Evaluation of Physical Barriers – Pedley Station

Address: 6001 Pedley Rd, Riverside, CA 92509

Evaluation Date: 08-05-2021

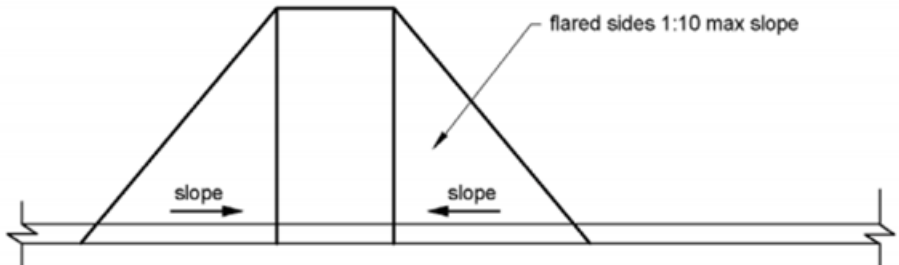
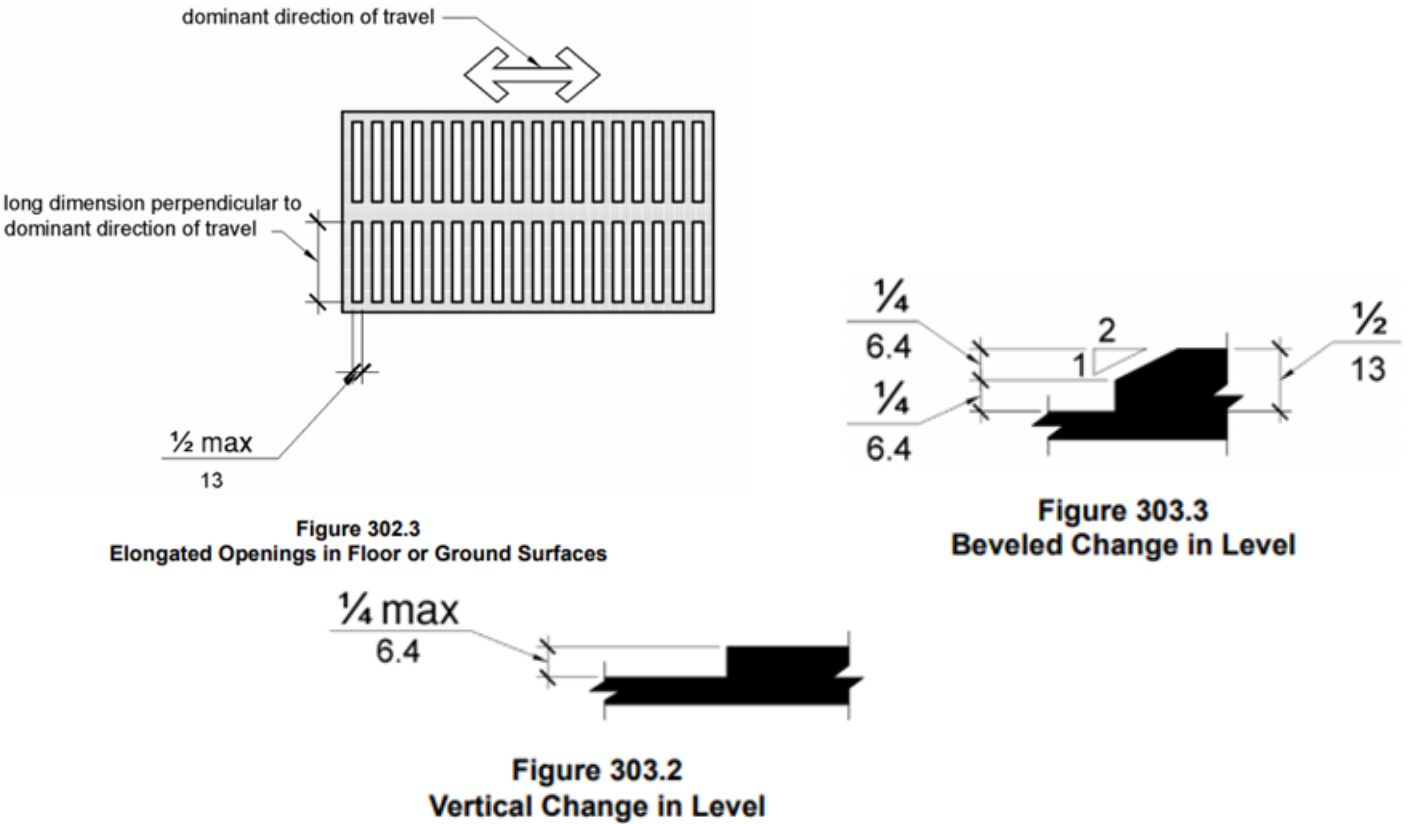
Issues/ Barrier Identified	Recommendations	Comments/ ADA Requirements
<p>1. Curb Ramps</p> <p>1a, 1b - OK 2a- OK 2b- <i>Gutter Slope exceeds 1:20</i> 3a, 3b, 3c, 4a, 4b, 5a, 5b: Slope of ramp exceeds 8.33% and slope of flared sides exceed 1:10. Detectable Warning Surface (DWS) is missing. 6a, 6b, 7a, 7b: <i>Level changes exceed ¼" without bevel, DWS is missing.</i></p> <div data-bbox="102 483 481 967">  </div> <p>Typical 6a thru 7b</p> <div data-bbox="515 499 1072 967">  </div> <p>Typical 3a thru 5b</p>	<p>2B: Confirm the slope of the gutter with appropriate instrument and repair as required.</p> <p>Curb ramps 3a through 5b need to be replaced to comply with applicable ADA requirements by City of Riverside.</p> <p>Repair curb ramp 4a which is the main accessible entry route.</p> <p>Curb ramps 6a thru 7b – Examine and repair to eliminate level changes and apply DWS.</p>	<p>Curb ramps are labeled on the aerial view on page 1</p> <p>See item 3a also for other ADA requirements</p> <p>This evaluation does not include curb ramps outside the RCTC boundary. RCTC is not responsible for maintaining the accessible routes outside of RCTC boundary.</p> <p>When repairs begin, use proper and precise instruments (4-foot smart level and 2-foot smart level) to fit within the curb ramp width and the adjacent gutter to measure ramp slopes, cross slopes, and counter slopes at all curb ramps (all stations). The long slope of ramp shall not exceed 1:12 (8.33%). Slope of flared sides shall not exceed 1:10 (10%), the gutter slope shall not exceed 1:20 (5%). Cross slope of the ramp and landing shall not exceed 1:50 (2%)</p> <p>Use smart level instruments, calibrated in accordance with manufacturer’s instructions before taking measurements.</p> <div data-bbox="1609 715 2262 856">  </div> <p>Figure 406.2 Counter Slope of Surfaces Adjacent to Curb Ramps</p> <p>406.3 Sides of Curb Ramps. Where provided, <i>curb ramp</i> flares shall not be steeper than 1:10.</p> <div data-bbox="1709 1078 2564 1330">  </div>

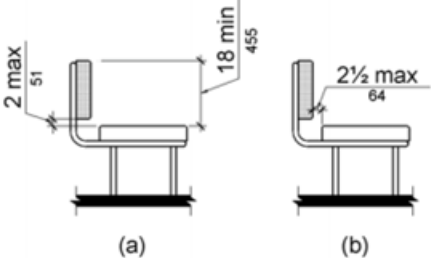
<p>Trails in the landscaped areas at the bus stops are not accessible. No accessible route leads to them and the walking path surface is not firm.</p> 	<p>If the park is not open for public use either, add signage prohibiting public access.</p>
